Model: MD-P2	Date: 18-Nov-2010	No.: RM075001i
--------------	-------------------	----------------

Subject: Firmware Release Note: Engine		Prepared by: H.Kobayashi	
From: 3rd Tech Service Sect., MFP/Printer Tech Service Dept.			
Classification:	<input type="checkbox"/> Troubleshooting <input type="checkbox"/> Mechanical <input type="checkbox"/> Paper path <input type="checkbox"/> Product Safety	<input type="checkbox"/> Part information <input type="checkbox"/> Electrical <input type="checkbox"/> Transmit/receive <input checked="" type="checkbox"/> Other (Firmware)	<input type="checkbox"/> Action required <input type="checkbox"/> Service manual revision <input type="checkbox"/> Retrofit information <input checked="" type="checkbox"/> Tier 2

Model: Model MD-P2		Date: 10-Feb-11	No.: RM075011
Subject: SC195/SC660		Prepared by: H.K.	
From: 2nd Overseas Tech Support Sec. 2nd PQM Dept			
Classification:	<input checked="" type="checkbox"/> Troubleshooting <input type="checkbox"/> Mechanical <input type="checkbox"/> Paper path <input type="checkbox"/> Product Safety	<input type="checkbox"/> Part information <input type="checkbox"/> Electrical <input type="checkbox"/> Transmit/receive <inpu

SC Condition (pg. 103)

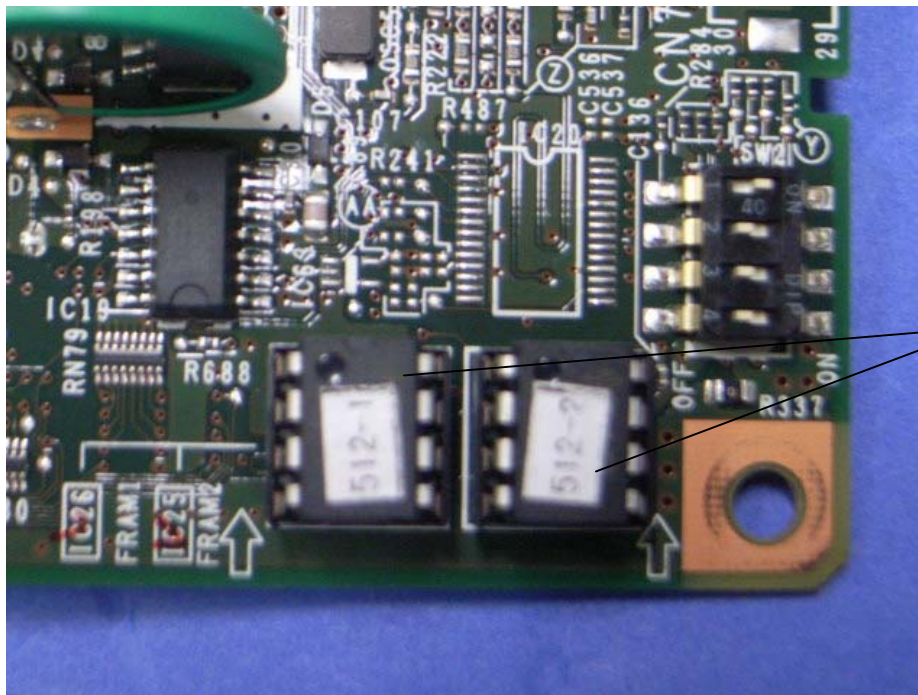
Correct the following:

Incorrect:

~~SC 1xx (Other Error)~~

~~195~~

Correct:

SC 6xx (Communication and Other Error)

660

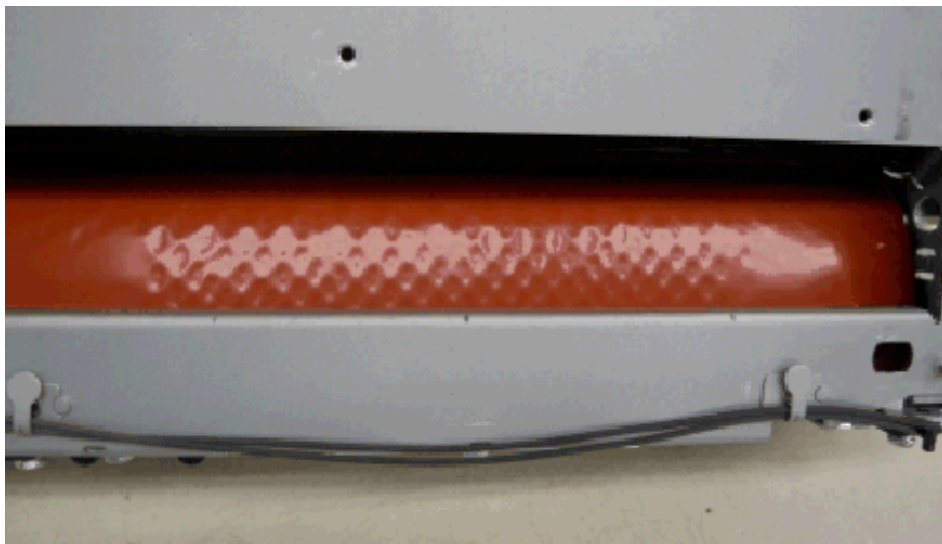
SC543 (High Temperature Detection Error) occurs ***during the following operations.***

- 1) When the power switch is turned ON, when the machine recovers from Sleep mode, or when the cover is being opened or closed.***

Note: In some cases, the fusing belt is deformed by high temperature, as shown below.

1) The Engine firmware was modified to **v01.06** to prevent this symptom.

2) *The Engine firmware was modified to **v01.07** to prevent this symptom.*

Flowchart for Proactive Visits

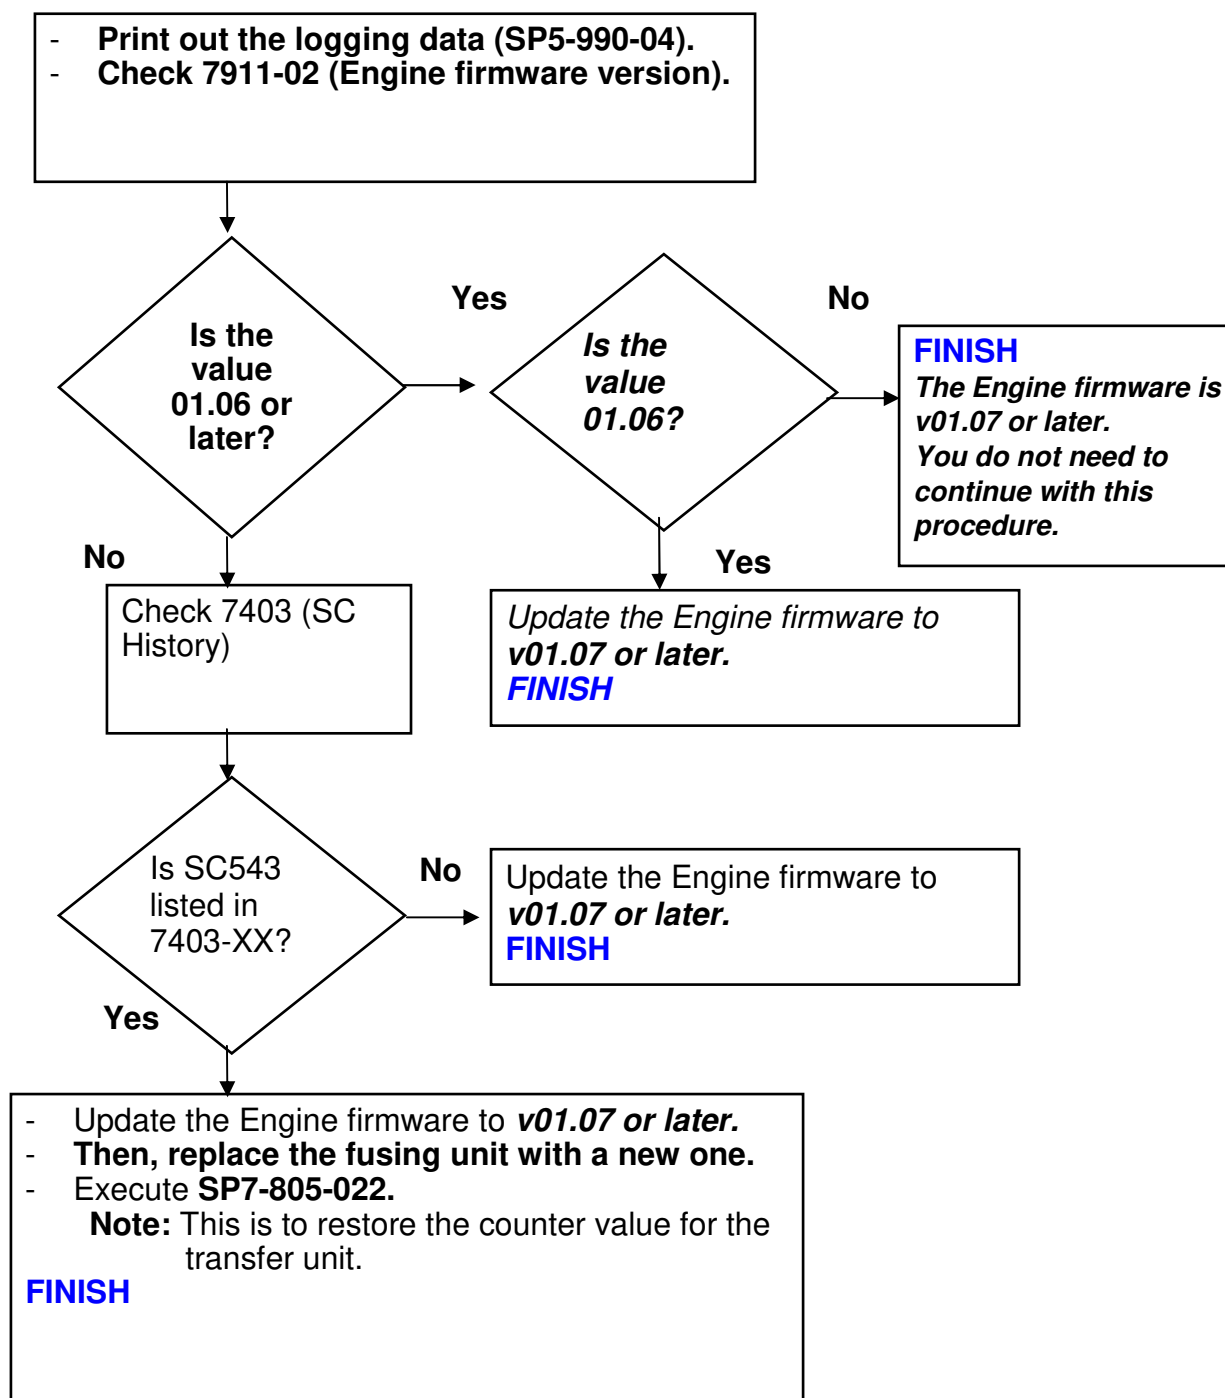
<<SEE THE FLOWCHART BELOW>>

- The new fusing unit has a “new unit detection” function, so you do not need to reset the fusing unit counter.
- If the fusing unit is replaced without the transfer unit, as in this procedure, the counter for the transfer unit will still be reset. This is why it is necessary to execute SP7-805-022.

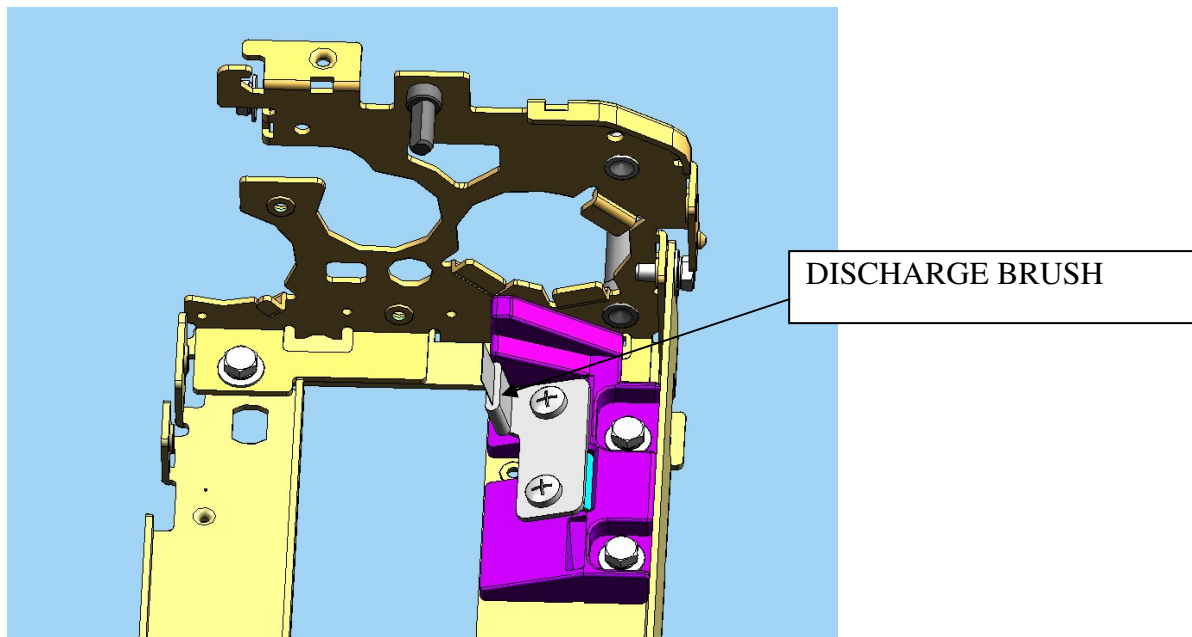
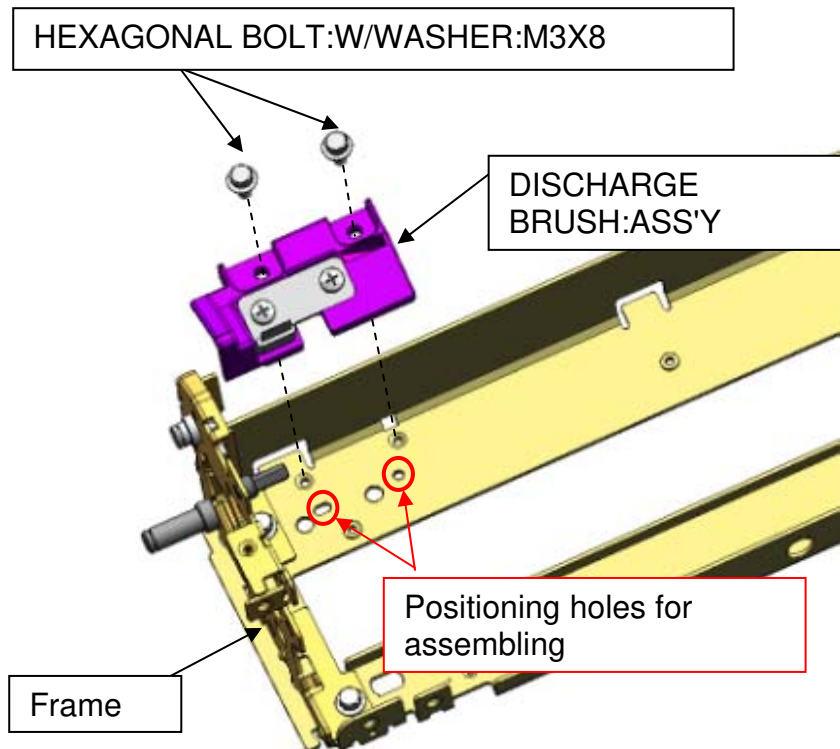
Change: The parts were newly added to the fusing unit.

Reason: To minimize the amount of paper dust attracted to the fusing belt when using paper types that contain a lot of paper dust.

- This is done by removing the static electric charge on the pressure roller.
- Discharge Brush Ass'y is attached directly to the fusing unit frame. To facilitate this change, two positioning holes and two bolt holes were cut in the frame.

08050089 → H5213355

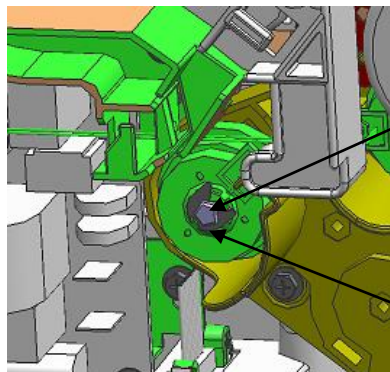
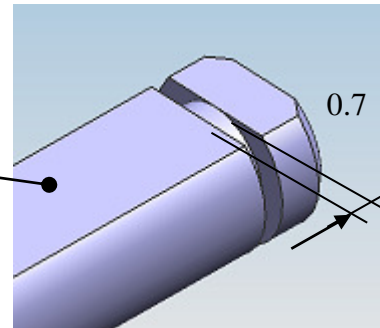
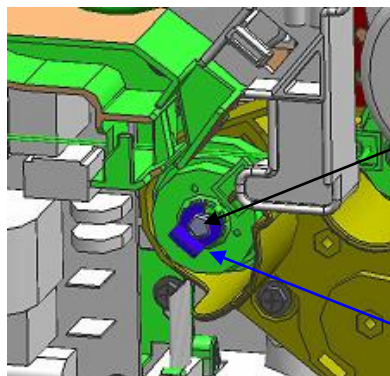
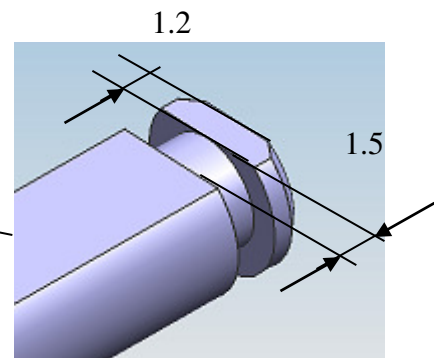
- 1) The width of the e-ring groove in the paper feed roller shaft was increased.
- 2) The e-ring was changed to a C-ring.

Reason: To facilitate assembly.

Old part number	New part number	Description	Q'ty	Int	Note
M0755215	M0755217	PCB:CTL:MD-P2:EXP:ASS'Y	1 - 1	X/O

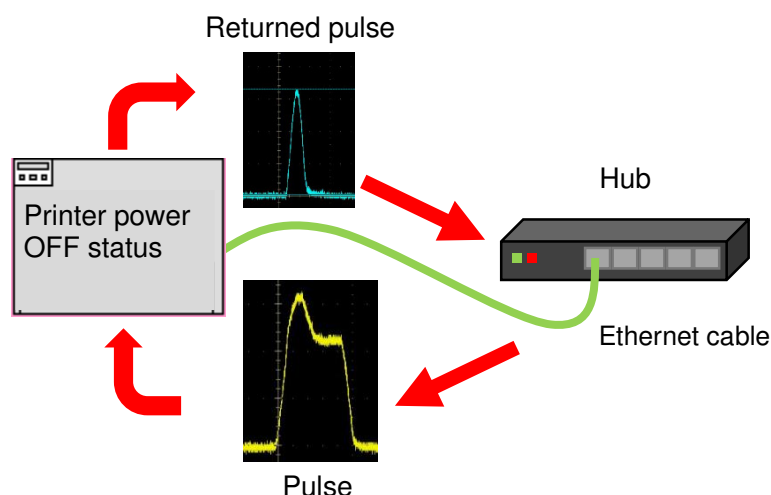
Interference in network communication may occur, if the printer is connected to a hub and the printer switch had been turned OFF (or the power cable was unplugged).

Pulses generated from hubs are transmitted to the printer while the printer is switched OFF (or unplugged). After being transmitted to the printer, they return to the hub, causing interference in network communication.

A circuit on the Controller Board was modified.

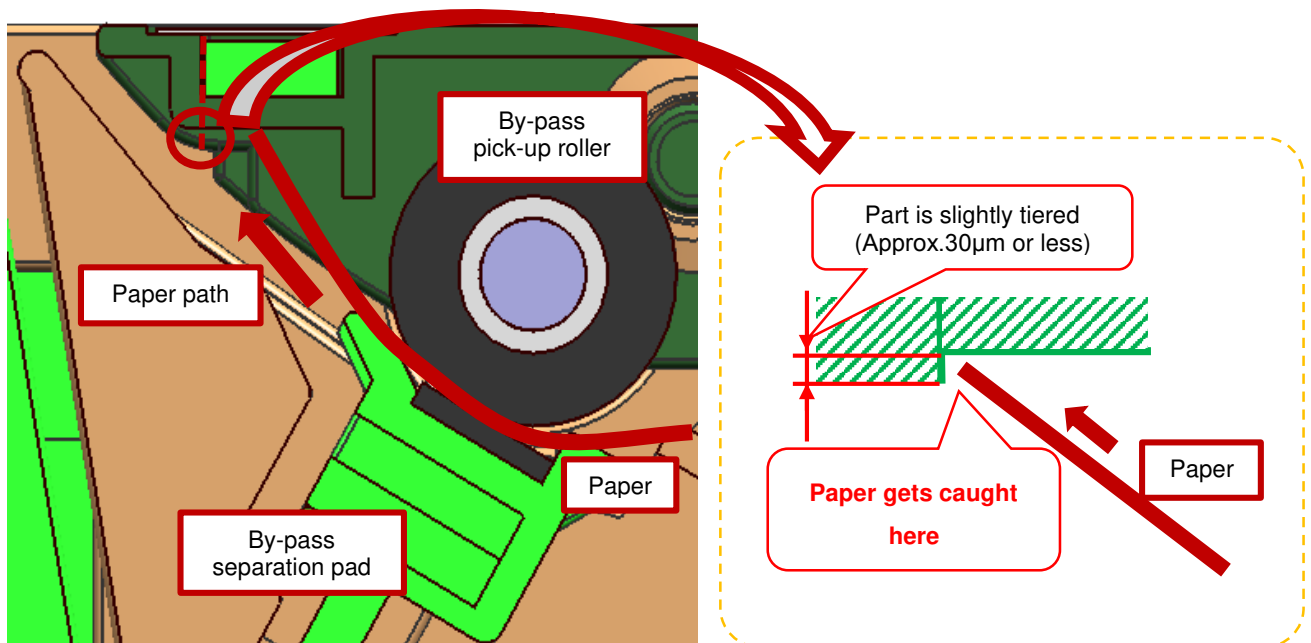
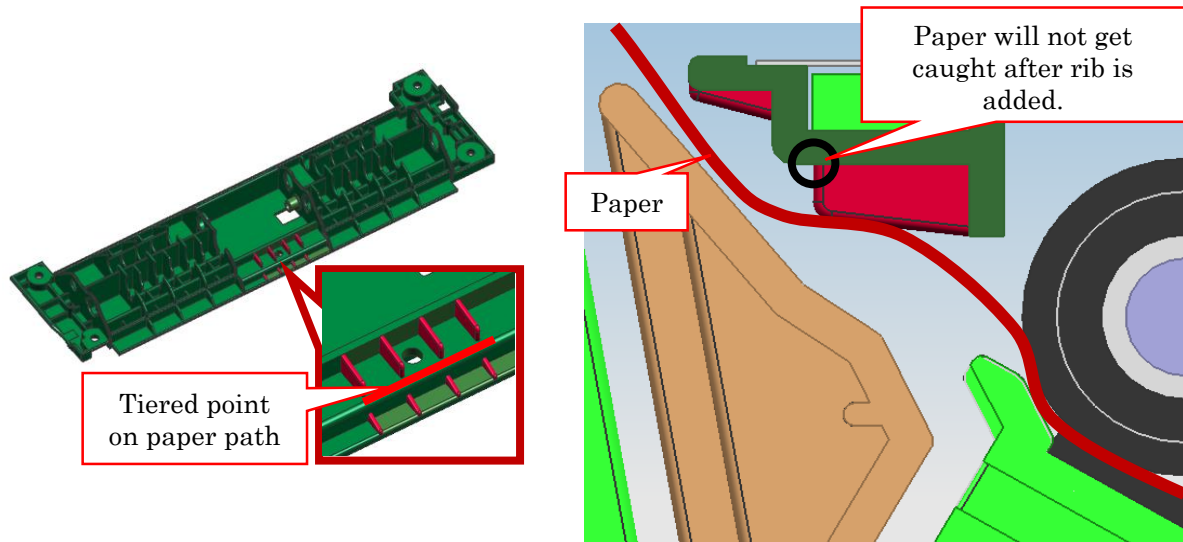
An old tool was used on the production line to produce the part shown below. As a result, the part was produced with a slightly tiered section (see diagram), and the paper may get caught here.

Four ribs were added to the area where the paper may get caught.
